Re: Final -TAC Application Letter of Intent for the Property Located at 3100 South Ocean Drive, Hollywood, Florida (Application No. 18-DJPV-60)

SUBJECT: Site Plan Review for an approximate 62,000 sq. ft. grocery store (Publix on the Beach).

APPLICANTS MUST ADDRESS ALL COMMENTS AND FINDINGS AS IDENTIFIED BY MEMBERS OF THE TECHNICAL ADVISORY COMMITTEE BOTH IN WRITING (IDENTIFY PAGE NUMBER OF THE CORRECTION) AND ON THE SITE PLAN (ALL CHANGES MUST BE IDENTIFIED, I.E. BUBBLED).

24" 0 6' 12' 3/3 3/32" = 1'-0"

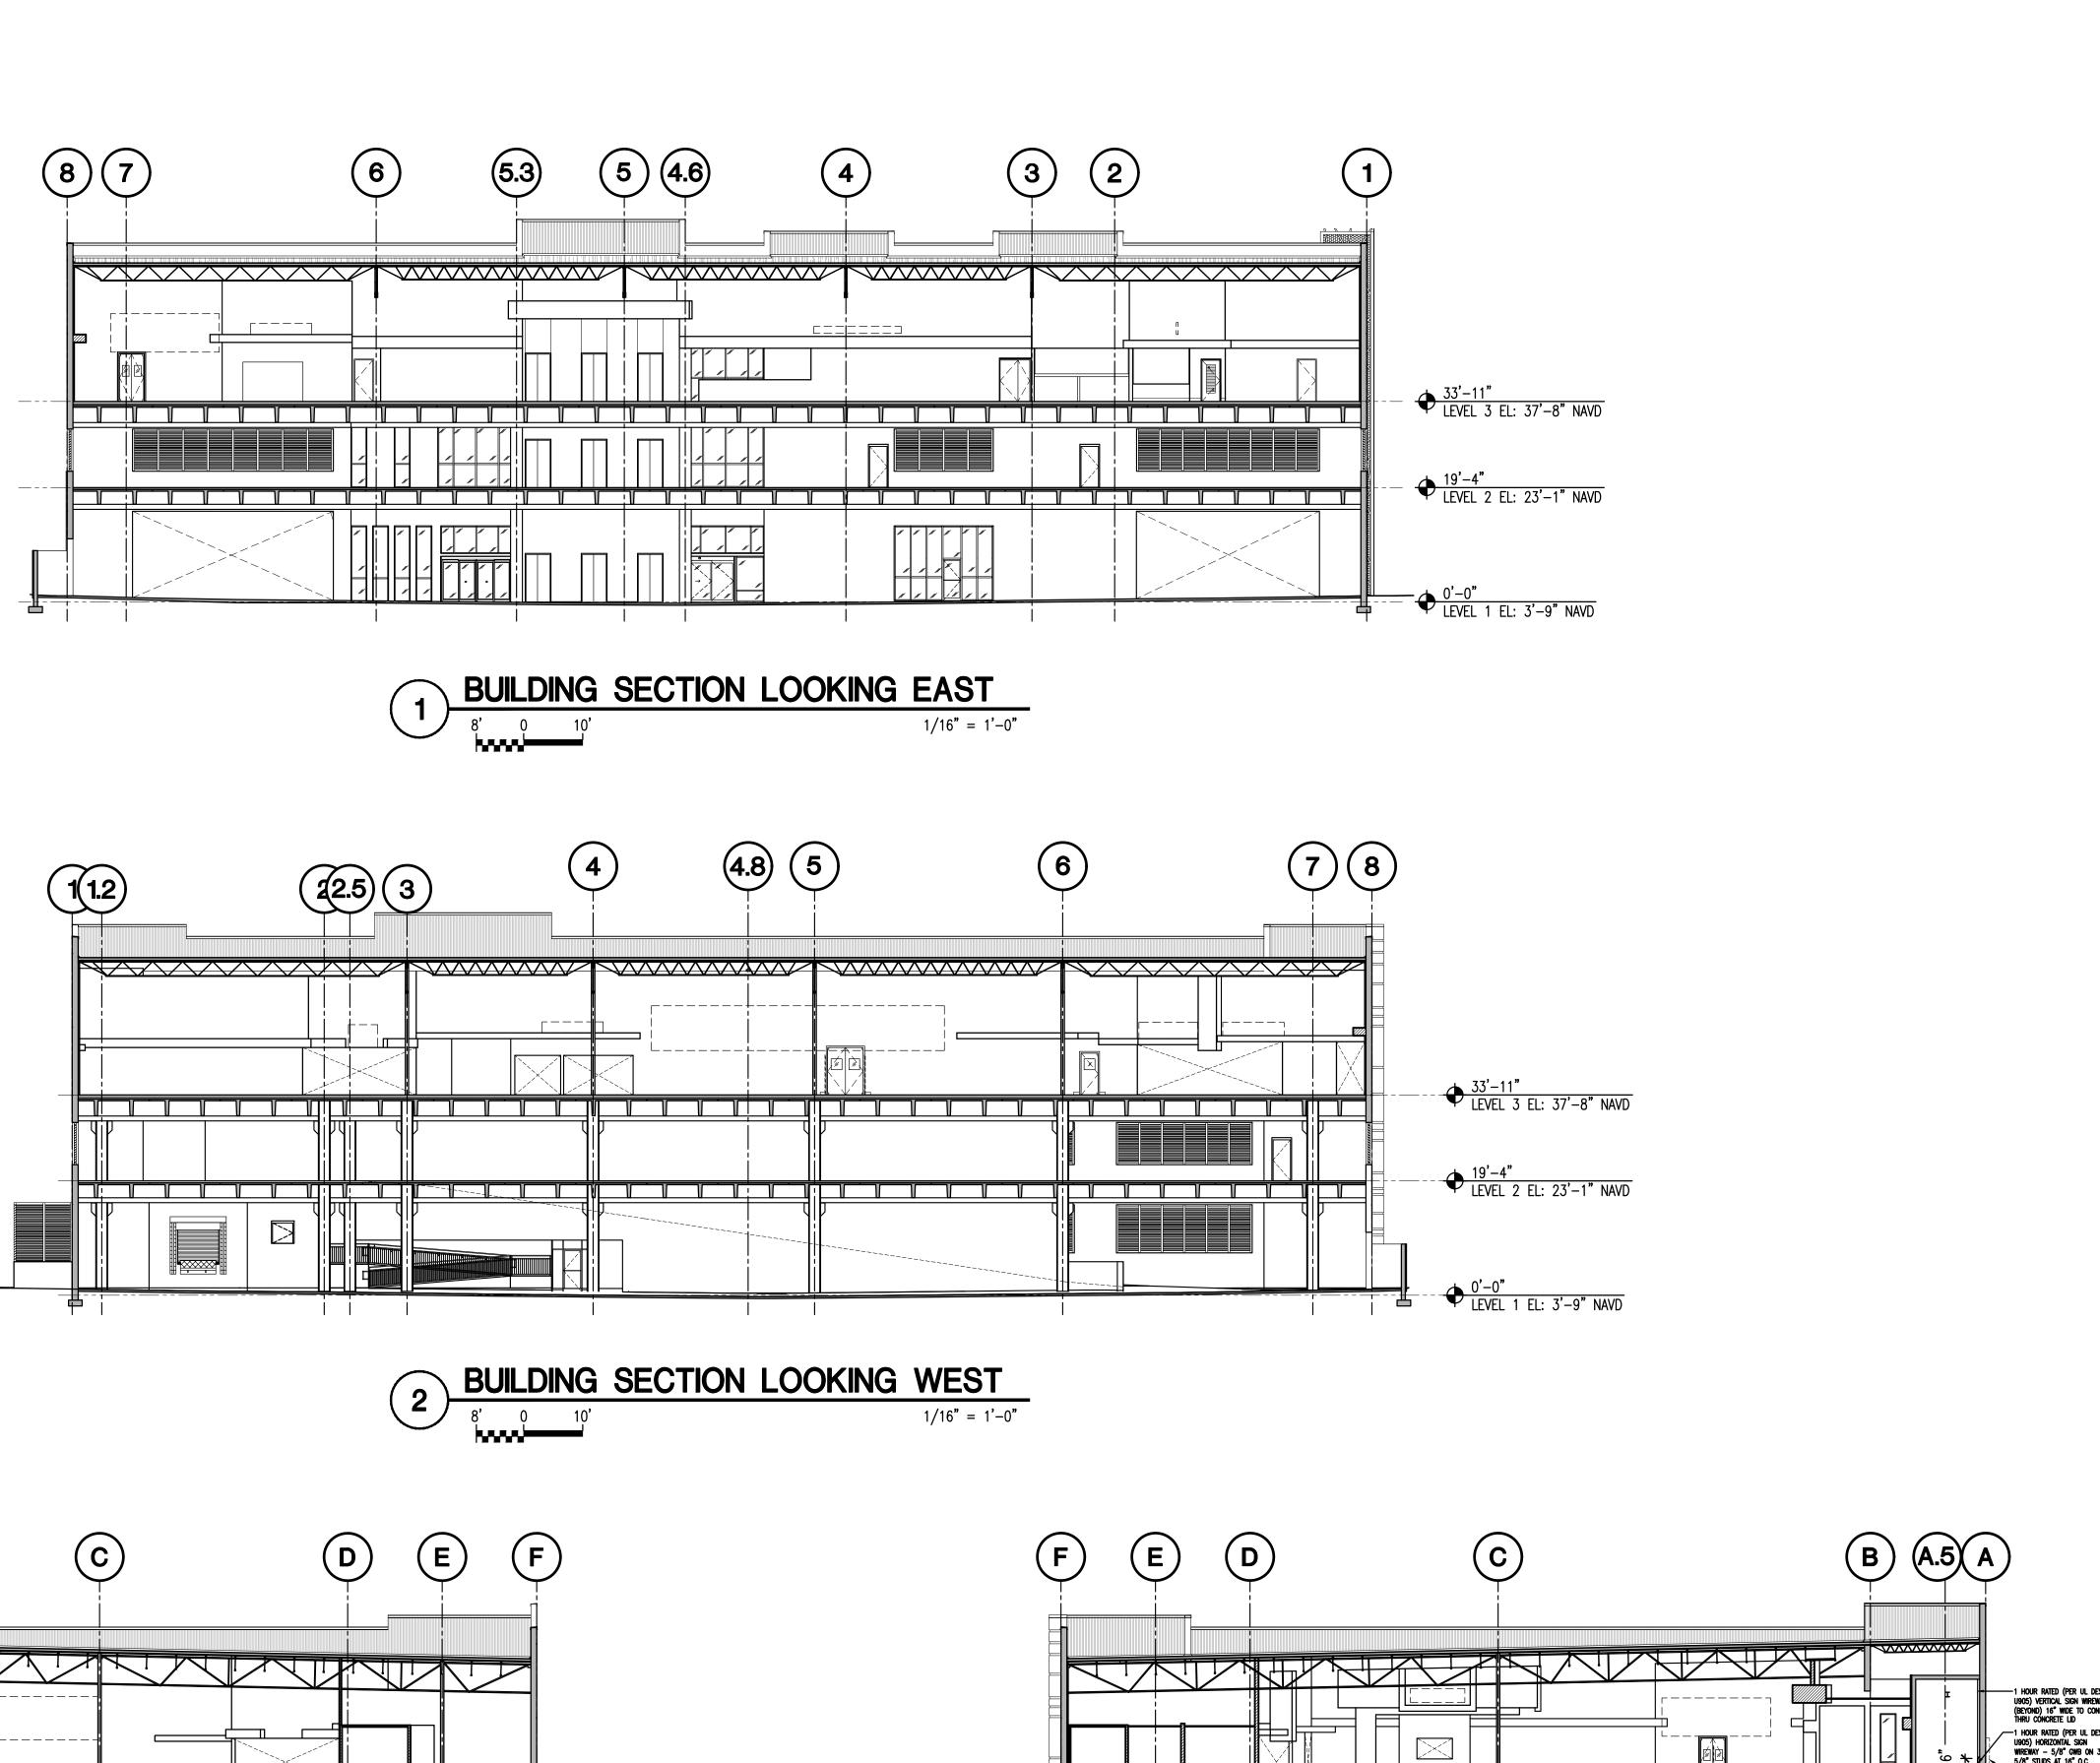
1. Sheet A4.1/A4.2 – upper portion of north/south/west elevations need additional architectural treatment.

Response – Acknowledged, we have further articulated the elevations on A4.1 and A4.2.

PUBLIX AT HOLLYWOOD
3100 S OCEAN DRIVE HOLLYWOOD, FL
TREE DISPOSITION PLAN

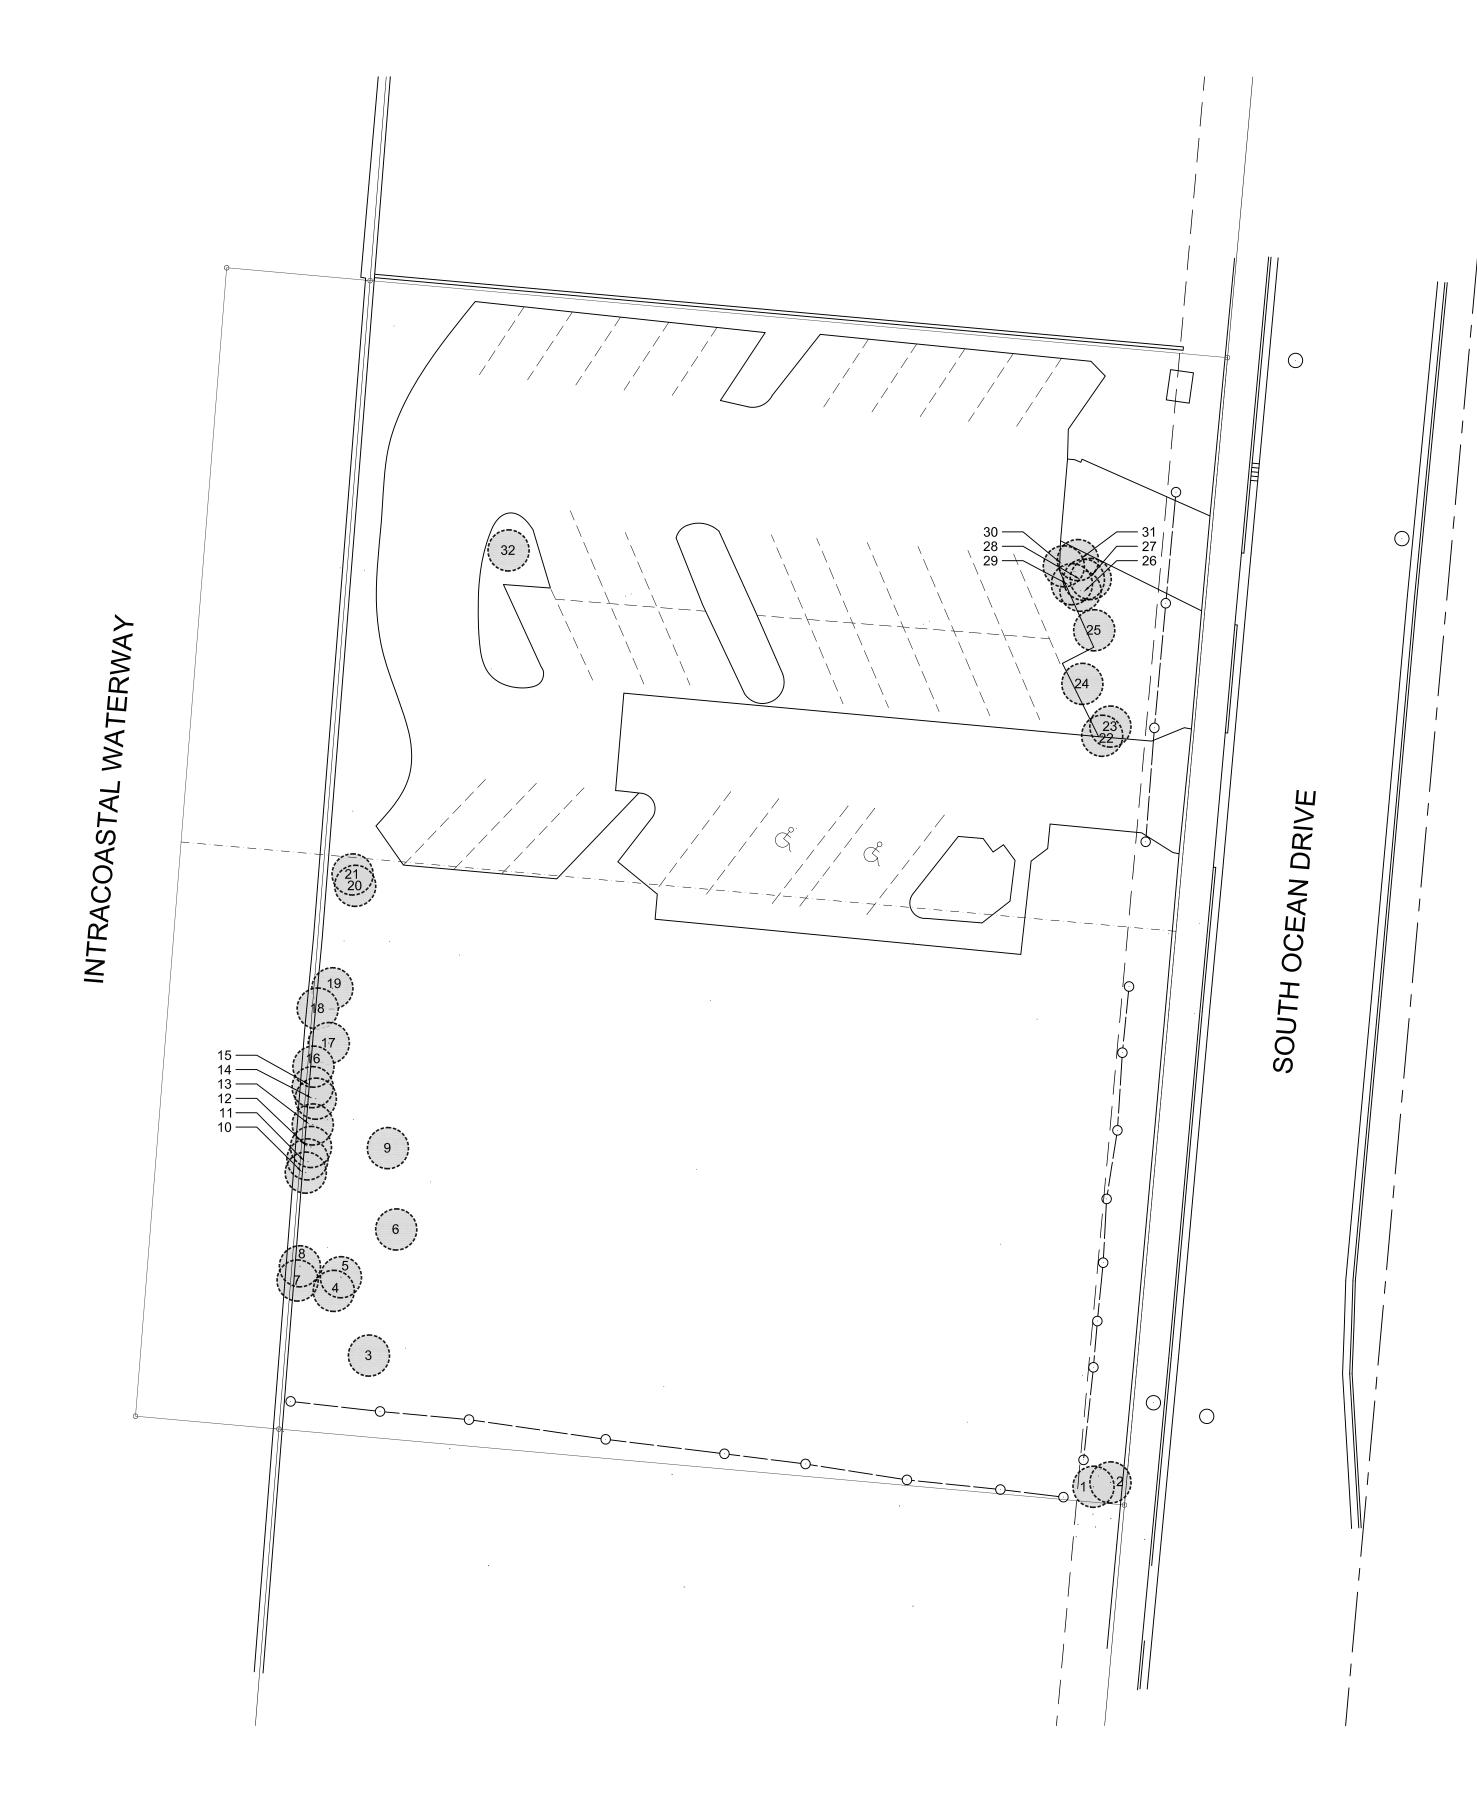
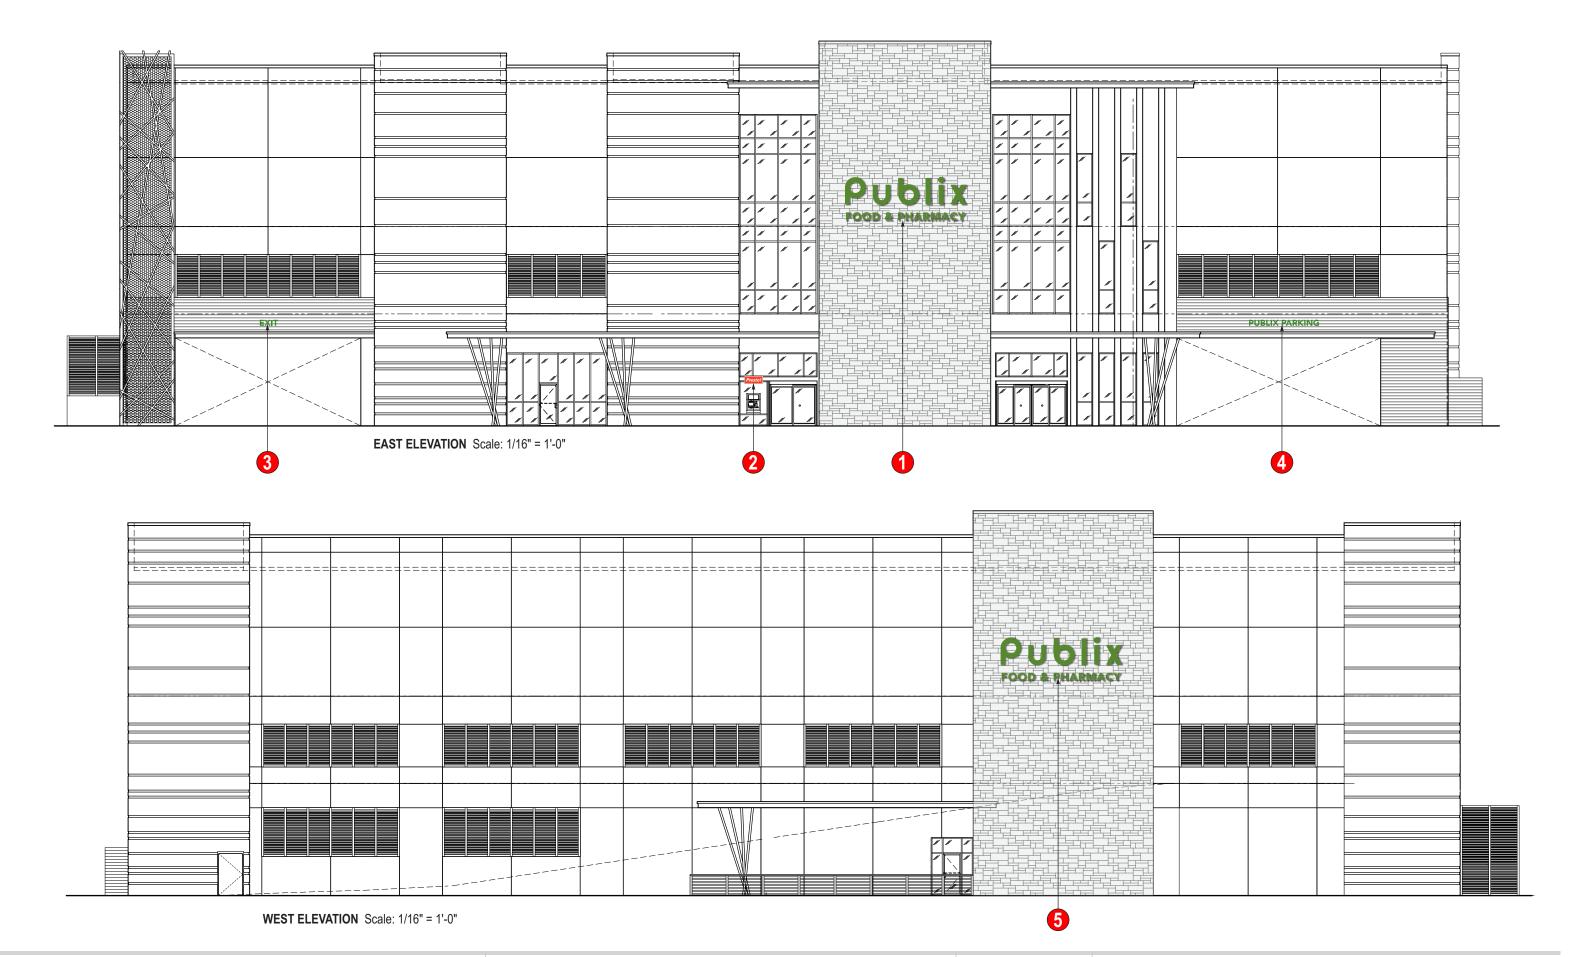
2. Provide a detailed tree disposition plan and landscape plan by a registered professional licensed Landscape Architect in the State of Florida that compliments the building architecture and uses, provides for shade, beautifies the site, accentuates site features, and serves as a buffer where appropriate. Provide tabular data chart on plan that identifies City of Hollywood landscape requirements and how they are being met for Perimeter landscape, Species diversity requirements, Interior landscape for at grade parking lots and vehicular use areas, open space, view triangle, planning and development board and historic preservation board and irrigation. Landscape plan should comply with all the requirements according to City of Hollywood Landscape manual, chapter 155.52, Article 9 LDR and section 6 landscape Plan details and specifications for technical review process. Landscape plan set to include and clarify what is been provided as per city code requirements for landscape for project type and what is provided for tree mitigation if any. As per submitted clarity is required in terms of amount of trees proposed to be removed.

Response – A tree disposition plan and landscape plan has been provided, sheets TD-1, L-1 & L-2. The landscape plan addresses requirements inclusive of perimeter landscape, species diversity, interior landscape, open space, and view triangle. Tree mitigation is shown on the provided.
